PROJECT: Pump Station 19 Decommission Project
City Project Number SS2018-01

ADDENDUM NO. 1
To the Contract Provisions for
CITY OF FERNDAL, WASHINGTON

Pump Station 19 Decommission Project
City Project Number SS2018-01

ADDENDUM 1

THORNTON STREET
PS19 DECOMMISSIONING
EX CONDITIONS, DEMO AND TESC - PS19 TO STA 5+50

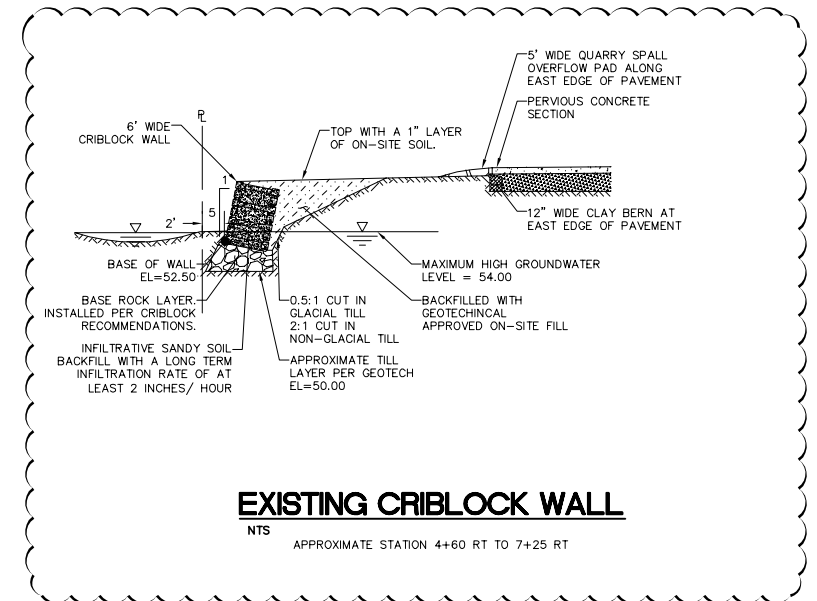
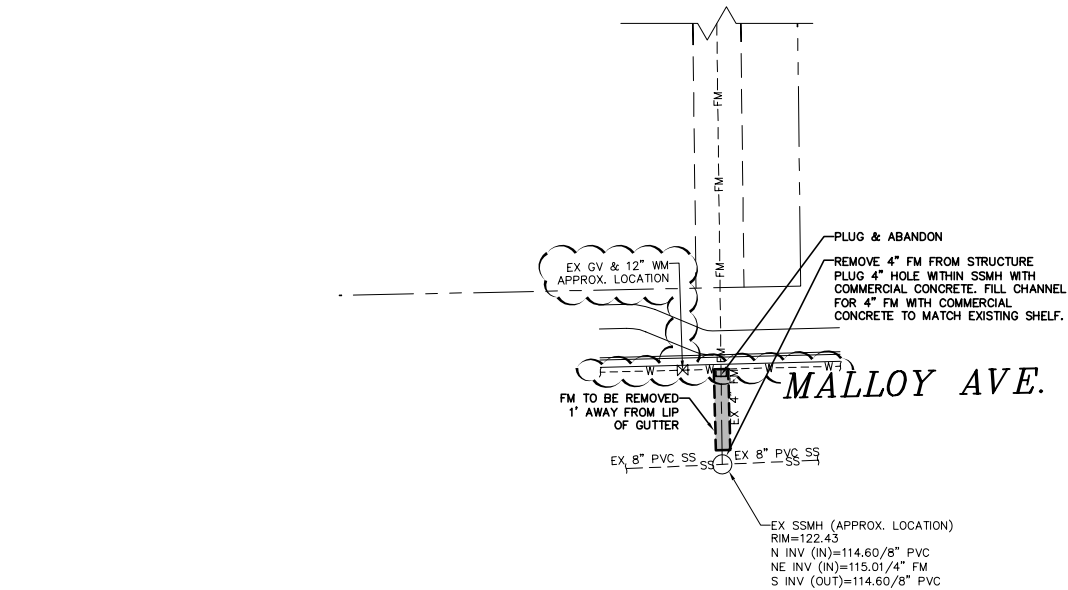
Sheet 3

- Existing trees and water utility locations were added.
- The existing Criblock Wall Detail was modified to better reflect As Built information.
- Inlet protections were removed from the cleanouts.

THORNTON STREET
PS19 DECOMMISSIONING
EX CONDITIONS, DEMO AND TESC - STA 5+50 TO STA 15+00

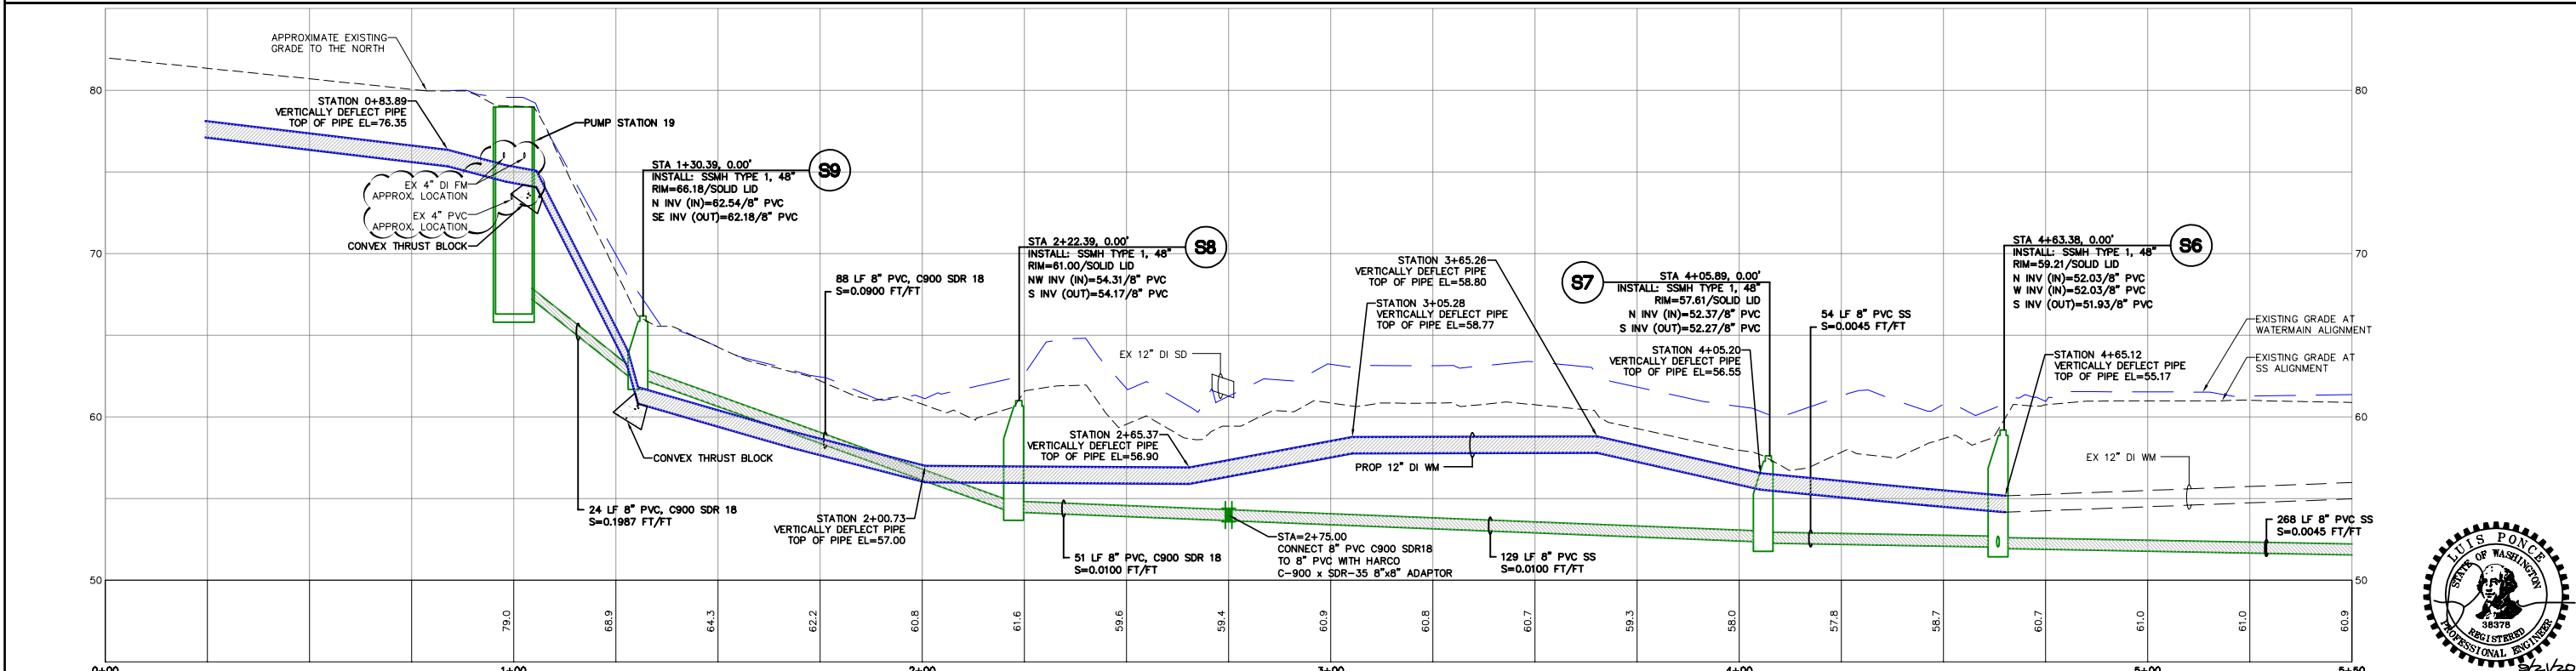
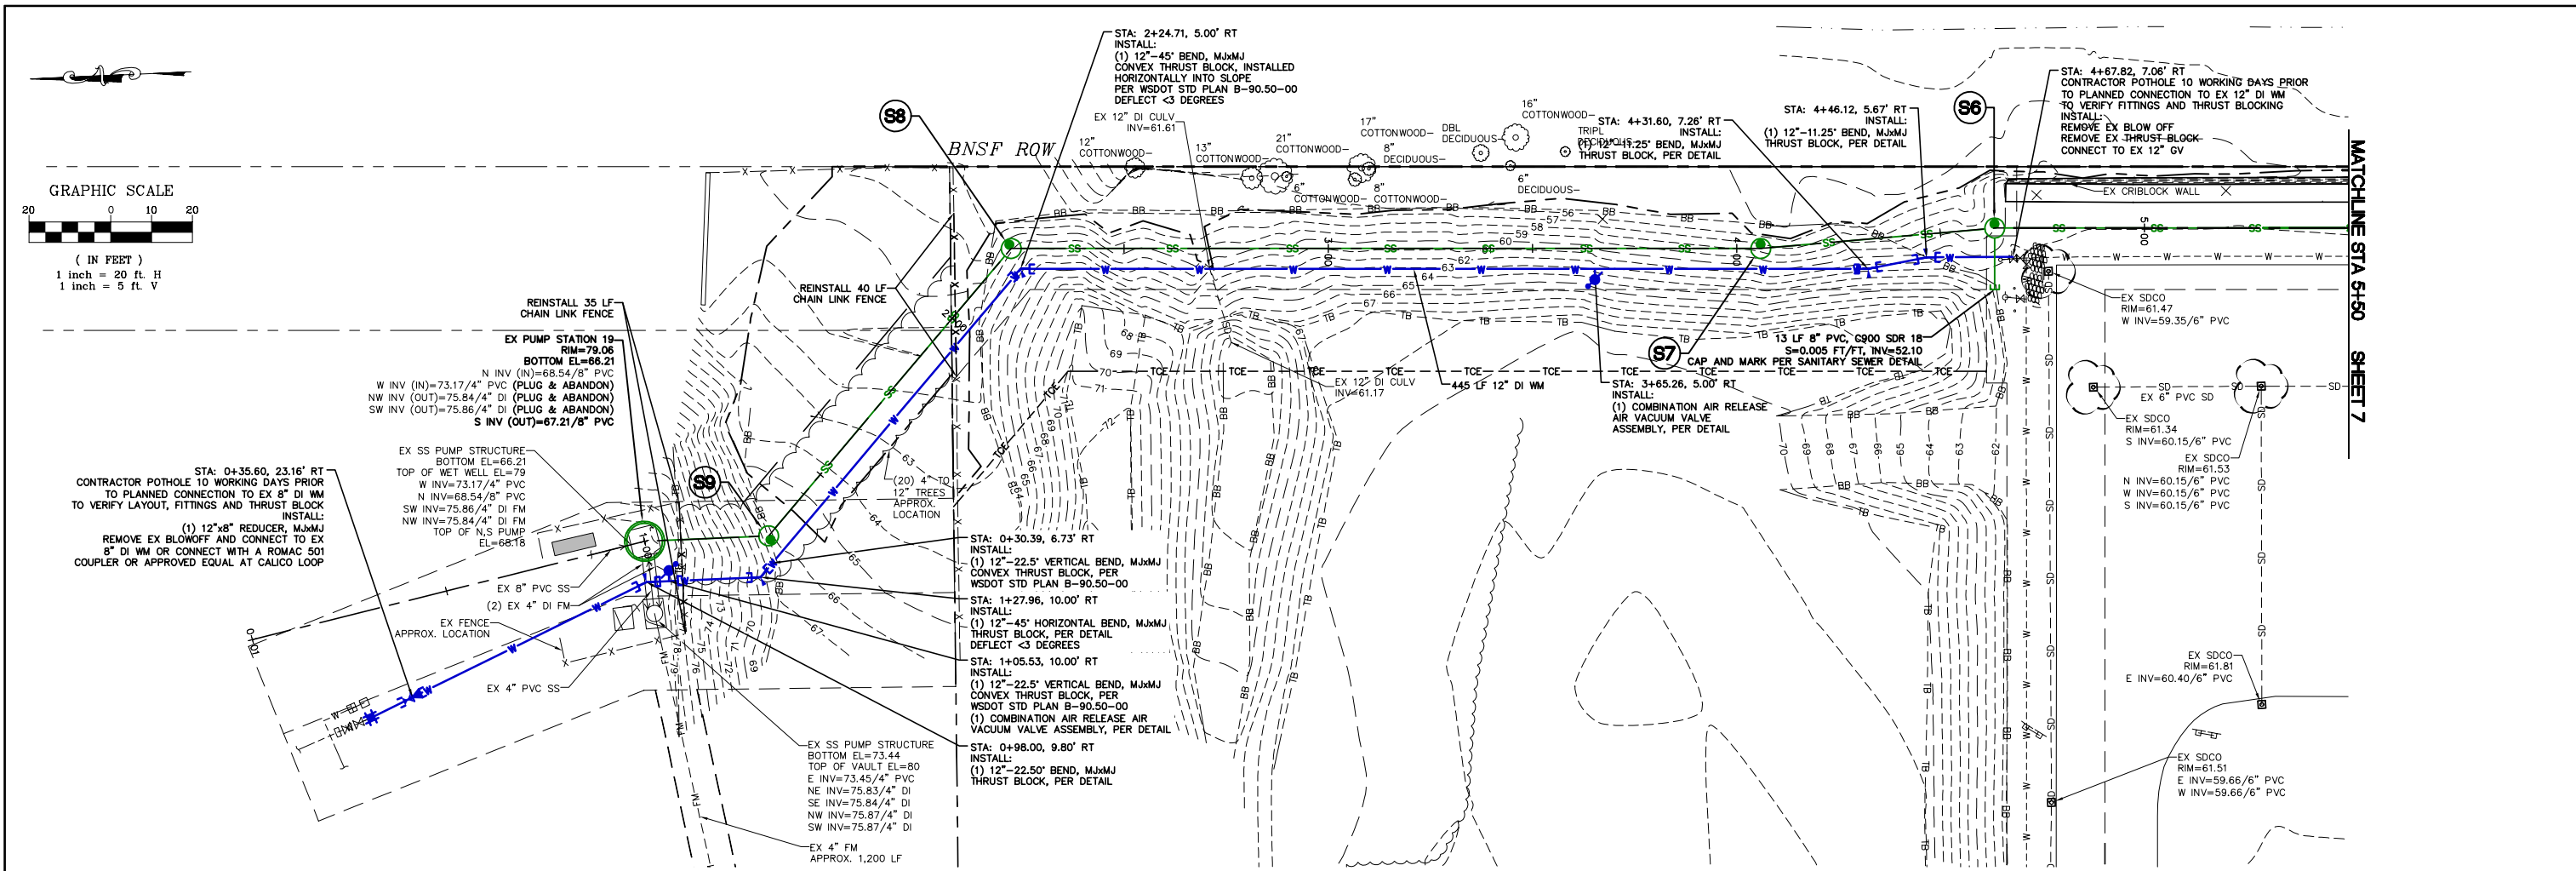
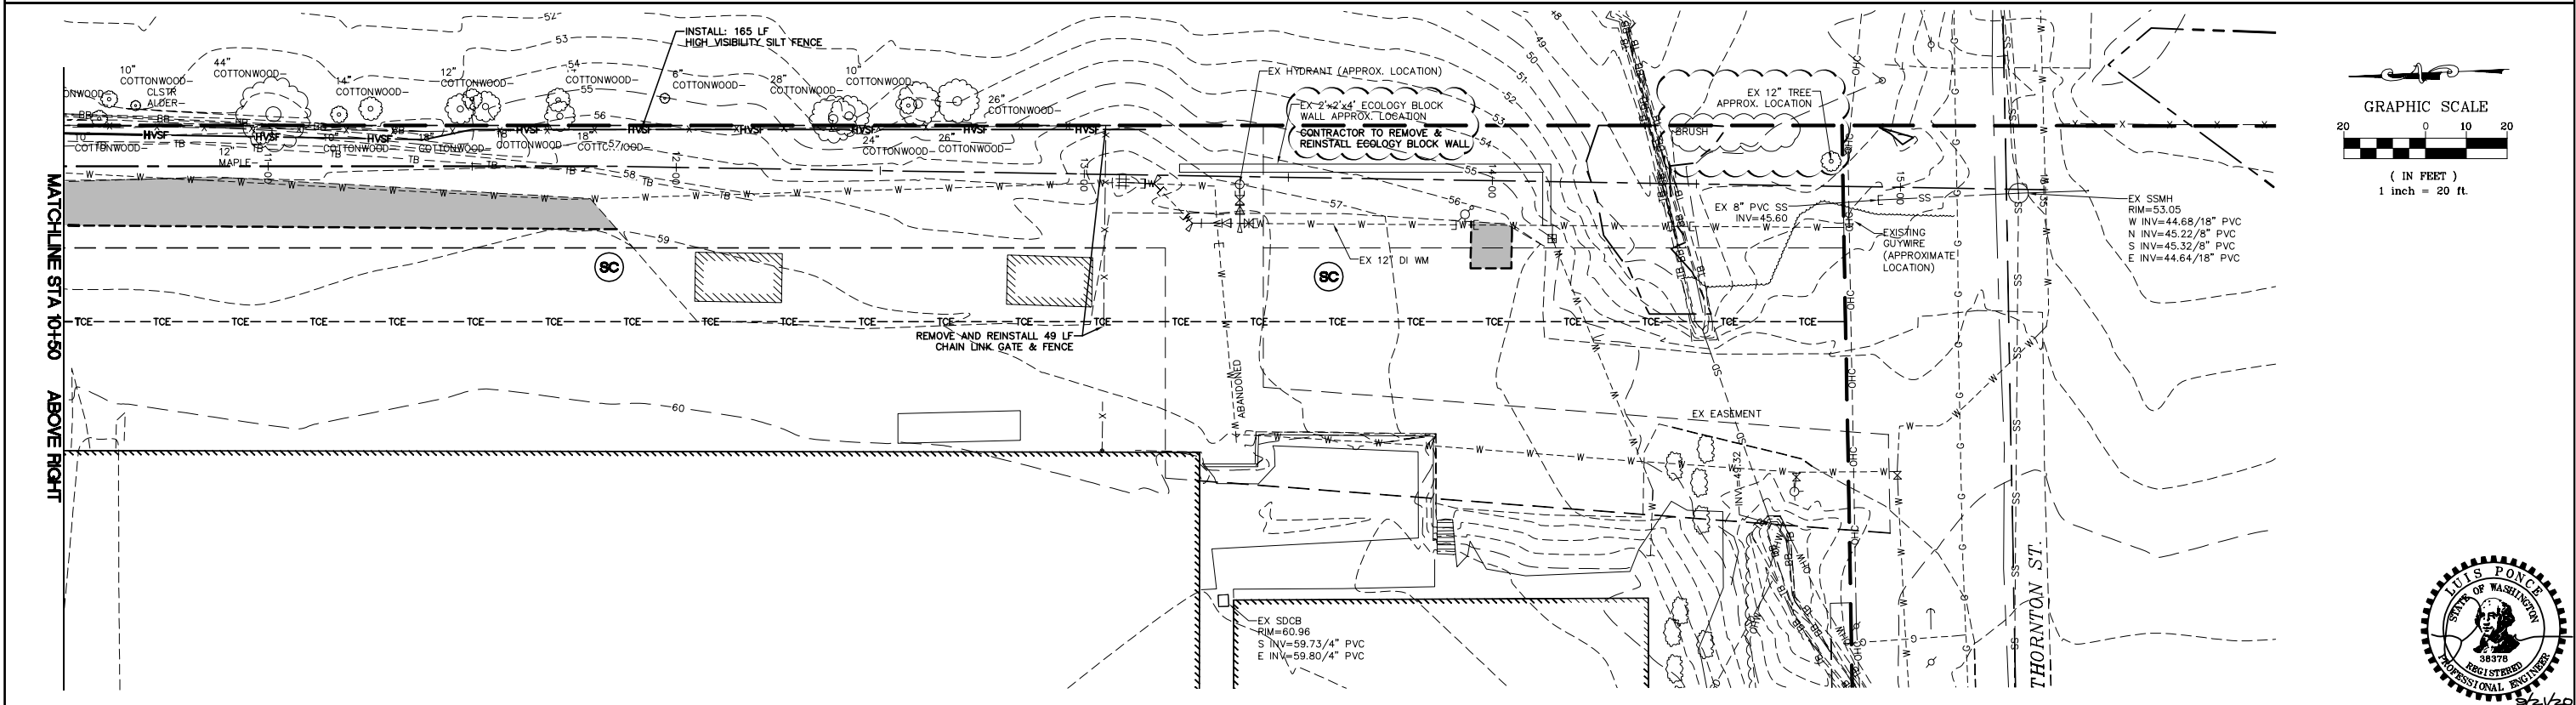
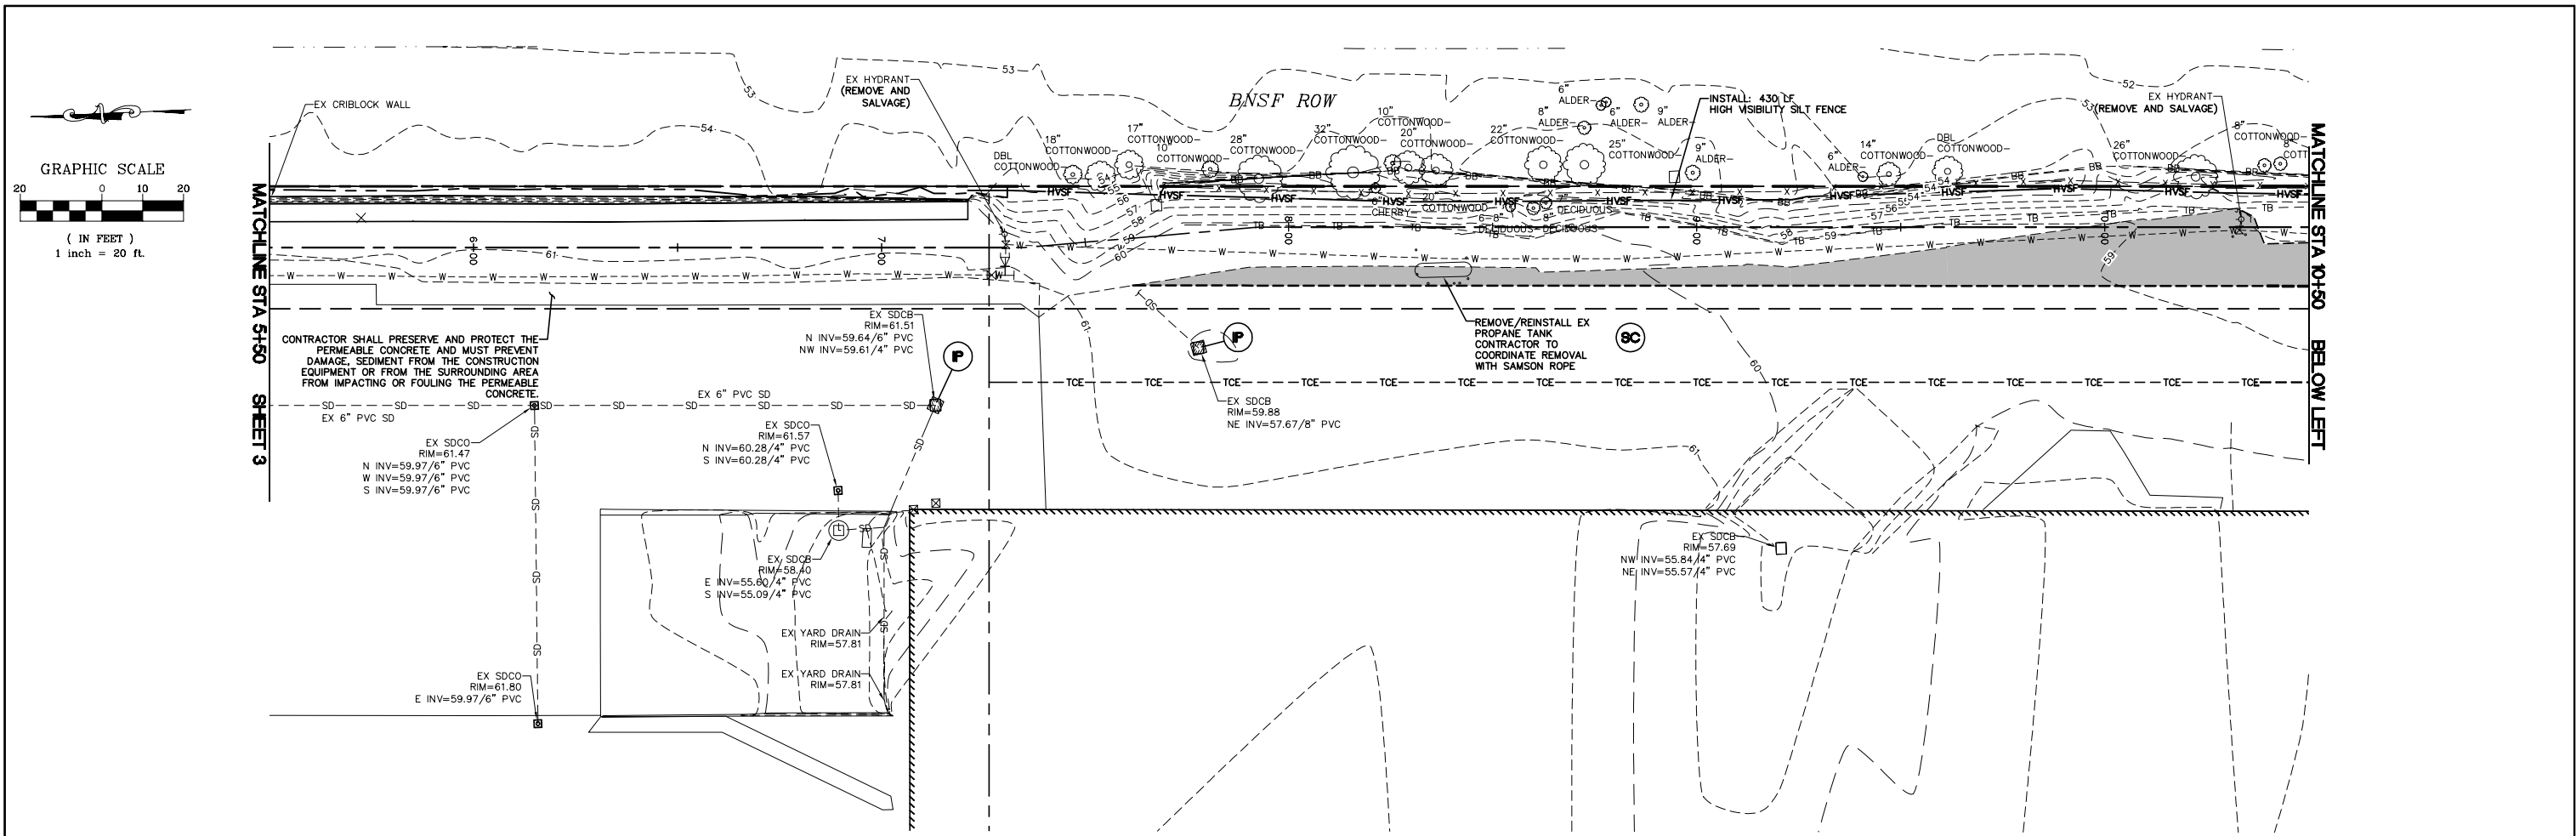
Sheet 4

- Existing trees and brush were added.
- A note regarding that the Contractor is to remove and reinstall the ecology block wall was added.
